AQ Matic Valve & Controls Company, Inc.

PERFORMANCE BULLETIN 129

58 Series Stager Motor Update

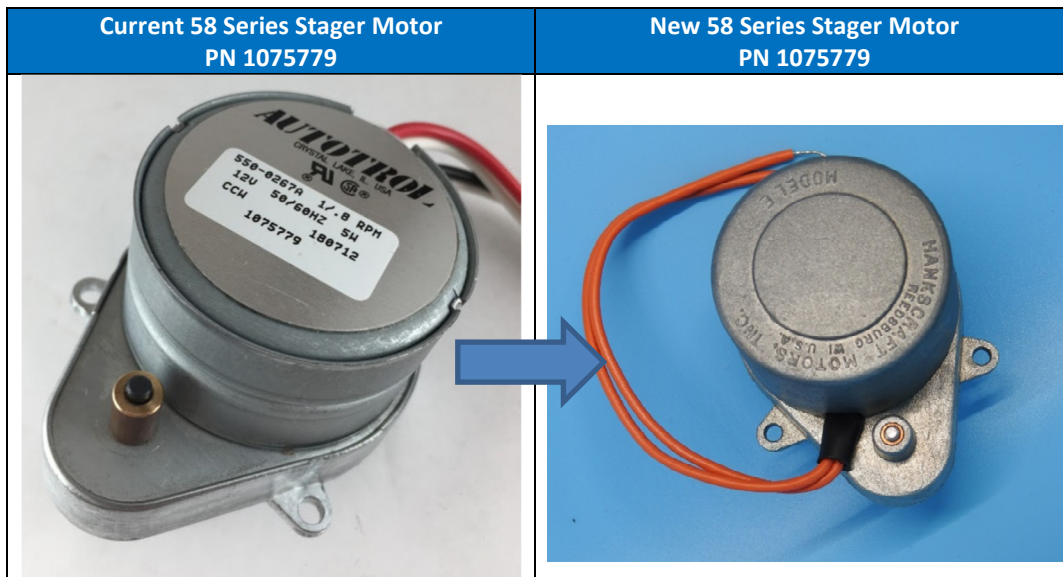
Due to a supply outage on 12 Volt 58 Series Stager motors PN 1075779, AQ Matic is transitioning to a new motor manufacturer. The new motors have slightly higher torque and are a direct replacement to the current except the new motors do not have a clutch. Because they do not have a clutch, **the new motors cannot be rotated by hand.**

If manual rotation of the stager is required with the new motors shown above, the two motor mounting screws will need to be removed and the motor disengaged from the stager cam.
